SERVICE BULLETIN NO: 070710-R1

Models: TX-SR605/DTR5.8

Subject: Static (pop) noise in DSP mode

Fig 2.

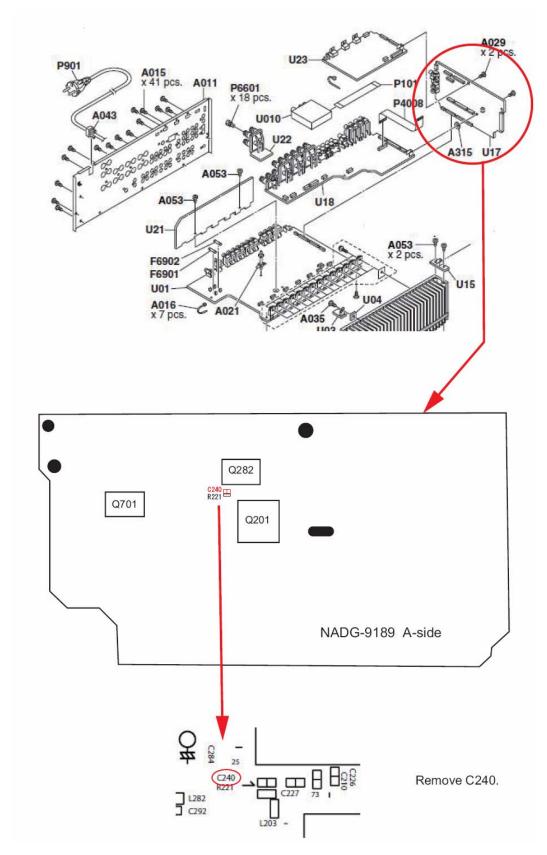
Symptom: During playback in any listening modes except Analog Direct, Multi-ch, and 2ch Pure Audio, Static (Pop) noise randomly comes out from all channel speakers, when the internal temperature is high. This noise stops when the unit is cooled (internal temperature is low)

Cause: When the internal temperature becomes high: depending on the variation of IC quality, SDRAM clock cannot catch up with the data reading speed.

When the above problem is reported, remove C240 from DSP Board NADG-9189. Place the unit as shown in Fig 1. below and then remove C240 as shown in Fig 2.

DSP Board: Remove C240
